SUBJECT: Kleiner Adjacent Subdivision – PFP  
[H-2023-0059](#)

LOCATION: 1730 N. Records Way at the northeast corner of N. Records Way and E. Fairview Ave., in the SW 1/4 of Section 4, T.3N., R.1E.

Combined preliminary and final plat consisting of two (2) building lots on 9.88 acres of land in the C-G zoning district.

NO.	DATE	BY	REVISION	1			CONTRACT PREPARED BY ARCHITECT'S PLAN														
NO.	DATE	BY	REVISION																						
1			CONTRACT PREPARED BY ARCHITECT'S PLAN																						
PROJECT: _____ SHEET NO. <b>PP2.0</b>		PREPARED BY: _____ CHECKED BY: _____ DATE: _____

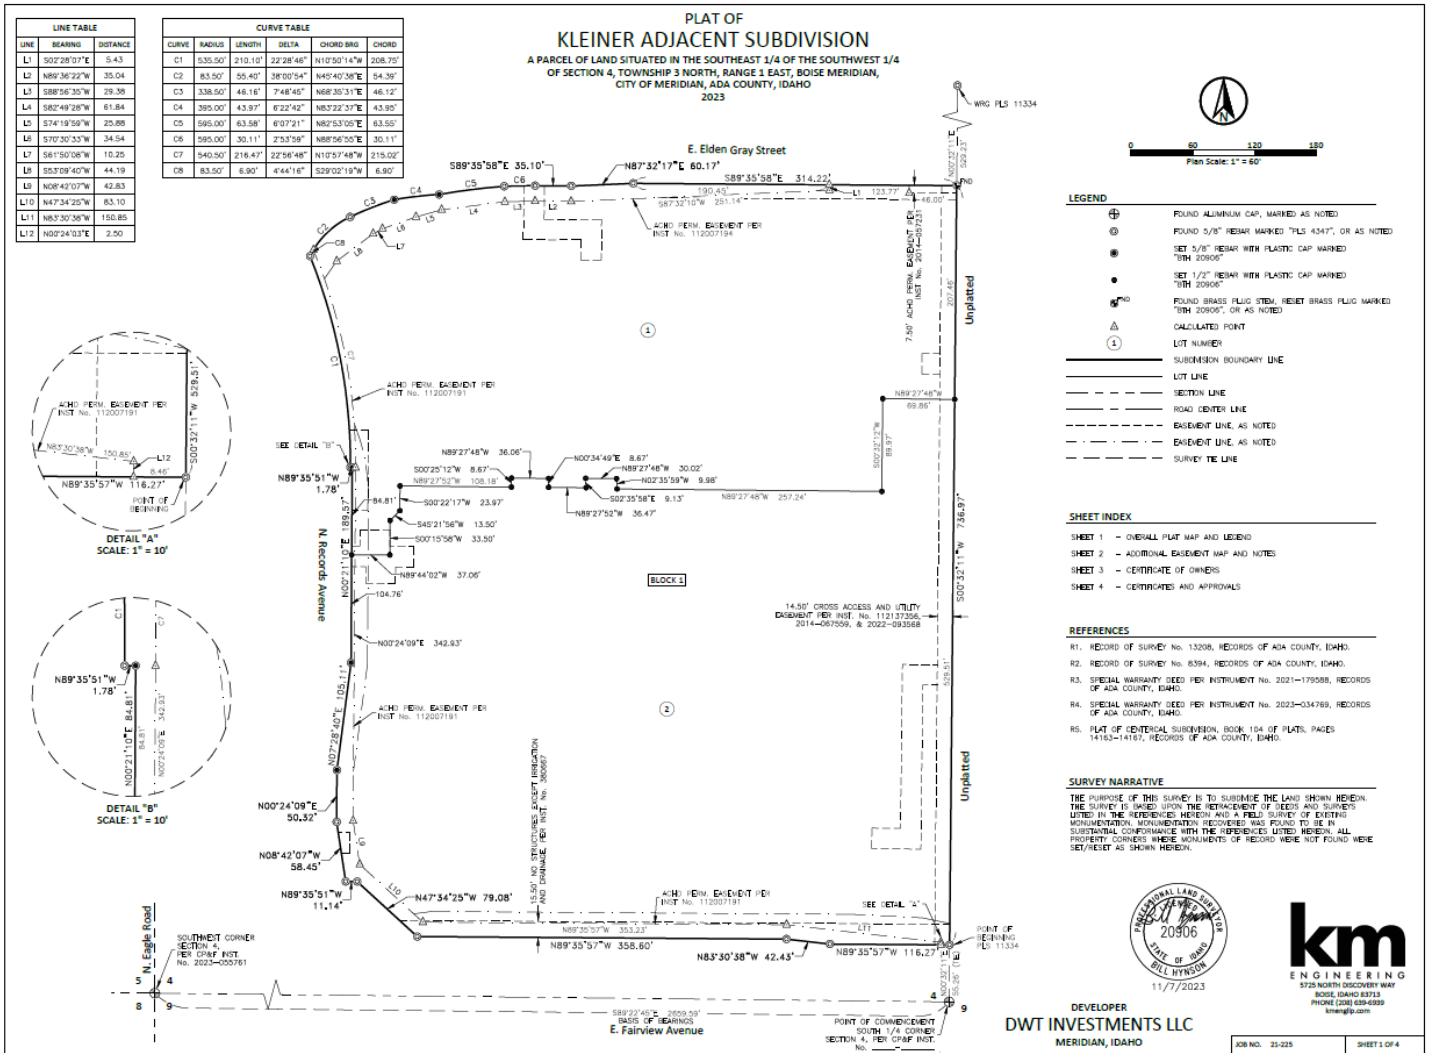
The proposed combined preliminary/final plat (PFP) consists of two (2) commercial building lots on 9.88 acres of land in the C-G zoning district as shown on the preliminary and final plats in Sections VIII.A and B.

**A cross-access easement is required to be granted to the abutting property to the east (CarMax Parcel #S1104438755) for use of the portion of the shared driveway that lies on this site. A recorded copy of the easement should be submitted with the final plat for City Engineer signature or prior to issuance of the first Certificate of Occupancy for the site, whichever occurs first. A blanket cross-access easement should also be granted between both of the proposed lots via a note on the plat.**

**Street buffers should be depicted on the plat in common lots or dedicated buffer easements, maintained by the property owner or business owner's association, as set forth in UDC [11-3B-7C.2a](#).** The buffers should be measured from the back of curb per UDC 11-3B-7C.1a(2).

**The minimum width of parkways planted with Class II trees is 8-feet; the planter width may be reduced to 6-feet if there are root barriers that meet the standards in UDC [11-3A-17E](#). The plat/landscape plans shall be revised accordingly to demonstrate compliance.**

**Pathways:** The Pathways Master Plan depicts 10-foot wide multi-use pathways along E. Fairview Ave. and N. Records Way providing a pedestrian connection to Kleiner City Park; pathways are proposed in accord with the Plan. **A 14-foot wide public pedestrian easement is required to be submitted to the Planning Division prior to submittal of the final plat for City Engineer signature or concurrent with the Certificate of Zoning Compliance application, whichever occurs first. If the pathway is partially located within the public right-of-way, provide sufficient easement width beyond that boundary to cover the 10' sidewalk plus 2' shoulder.**

- 1.1 The final plat submitted for City Engineer signature shall include the following revisions:
- a. Depict street buffers in common lots or dedicated buffer easements, maintained by the property owner or business owner's association, as set forth in UDC [11-3B-7C.2a](#)

- b. Widen the street buffer along Fairview Ave. to a minimum 35-feet in accord with the minimum standards in UDC [11-2B-3](#). An additional 2-feet shall be added to the width of the buffer along Fairview totaling 37-feet if wheel stops aren't provided in abutting parking spaces as set forth in UDC [11-3C-5B.4](#). *If an alternative compliance application will be requested for a reduced buffer width, it should be submitted to the Planning Division prior at least 15 days prior to the City Council hearing.*

- c. Depict a cross-access ingress/egress easement on the plat granting access to the abutting property to the east (Parcel #S1104438755) for use of the existing shared driveway; or, submit a separate copy of a recorded agreement to the Planning Division with the final plat for City Engineer signature or prior to issuance of the first Certificate of Occupancy for the site, whichever occurs first.

- d. Include a note granting a blanket cross-access and cross-parking easement between the proposed lots.
  - e. Include a note that states all common areas and site amenities will be shared between the two (2) lots/properties and maintained by the business owner's association for the development.

- e. The minimum width of parkways planted with Class II trees is 8-feet; the planter width may be reduced to 6-feet if there are root barriers that meet the standards in UDC [11-3A-17E](#); revise plans accordingly.

- f. Graphically depict a 14-foot wide public pedestrian easement for the multi-use pathways along E. Fairview Ave. and N. Records Way; include the instrument number of the recorded easement.

- g. Drainage and utility easements shall be noted on the final plat that benefit/serve both of the proposed lots.
- 1.2 The landscape plan submitted with the final plat for City Engineer signature shall include the following revisions:

B. Final Plat (dated: 11/7/23)

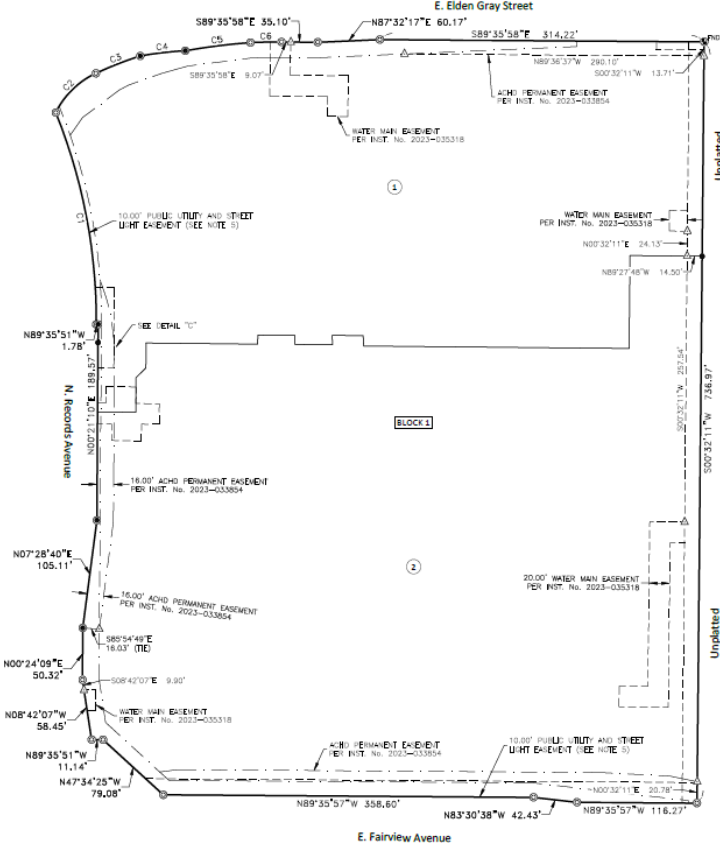
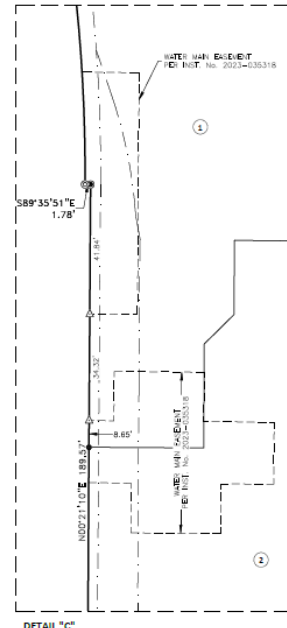
**Parking:** Off-street parking is provided on the site and will be reviewed for consistency with the standards listed in UDC [Table 11-3C-6](#) with the Certificate of Zoning Compliance application. **A blanket cross-parking easement should be granted between both of the proposed lots via a note on the plat.**

**Open Space & Amenities:** All common areas and site amenities will be shared between the two (2) lots; **a note should be included on the final plat accordingly.**

**Utilities (UDC 11-3A-21):** Connection to City water and sewer services is required in accord with UDC 11-3A-21. **Utility easements should be noted on the final plat that benefit both of the proposed lots.**

**Storm Drainage (UDC 11-3A-18):** An adequate storm drainage system is required in all developments in accord with the City's adopted standards, specifications and ordinances. Design and construction shall follow best management practice as adopted by the City as set forth in UDC 11-3A-18. A [Geotechnical Investigation report](#) was submitted with this application. **Drainage easements should be noted on the final plat that benefit both of the proposed lots.**

# C. Landscape Plan (dated: 11/7/23)

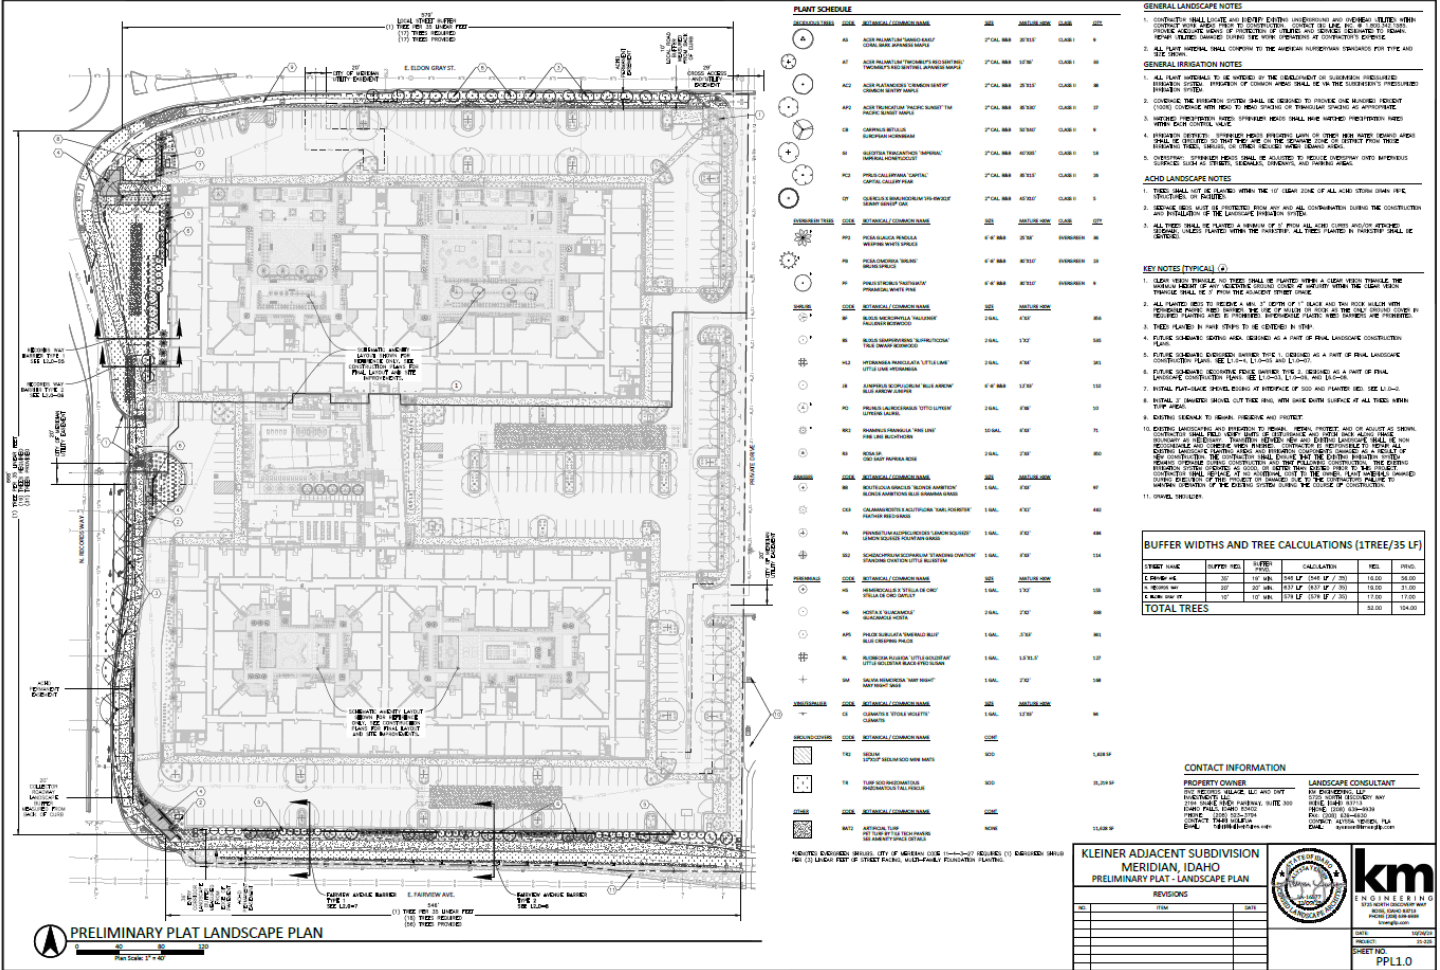
**Landscaping (UDC 11-3B):** The UDC ([Table 11-2B-3](#)) requires a minimum 35-foot wide street buffer along E. Fairview Ave., a principal arterial street and entryway corridor; a 20-foot wide buffer along N. Records Way, a commercial collector street; and a 10-foot wide buffer along E. Elden Gray St., a local street. Where bumpers overhang onto perimeter landscape buffers in parking areas, the parking stall dimensions may be reduced 2 feet in length if 2 feet is added to the width of the landscaped area planted in groundcover; otherwise, wheel stops should be provided to prevent vehicle overhang.

A reduced buffer width of 16 feet was previously approved through alternative compliance [A-2022-0085](#) along a 145-foot long section adjacent to the right-turn lane along N. Records Way. **An additional 2-feet should be added to the width of the buffer along Fairview totaling 37-feet if wheel stops aren't provided in abutting parking spaces. ALL of the buffer area must be vegetated in accord with the standards listed in UDC [11-3B-7C.3](#) – the gravel shoulder (or any other unlandscaped areas) may not be counted toward the minimum width of the buffer; the plans should be revised accordingly. If a hardship exists, a reduced buffer width may be requested through an alternative compliance application as set forth in UDC 11-3B-7C.1c. The buffer width along Elden Gray includes an additional 2-feet for vehicle overhang as required.**

- a. The minimum width of parkways planted with Class II trees is 8-feet; the planter width may be reduced to 6-feet if there are root barriers that meet the standards in UDC [11-3A-17E](#); revise plans accordingly.

- b. Widen the street buffer along Fairview Ave. to a minimum 35-feet in accord with the minimum standards in UDC [11-2B-3](#). An additional 2-feet shall be added to the width of the buffer along totaling 37-feet if wheel stops aren't provided in abutting parking spaces as set forth in UDC [11-3C-5B.4](#). The entire buffer shall be vegetated in accord with the standards listed in UDC [11-3B-7C.3](#).
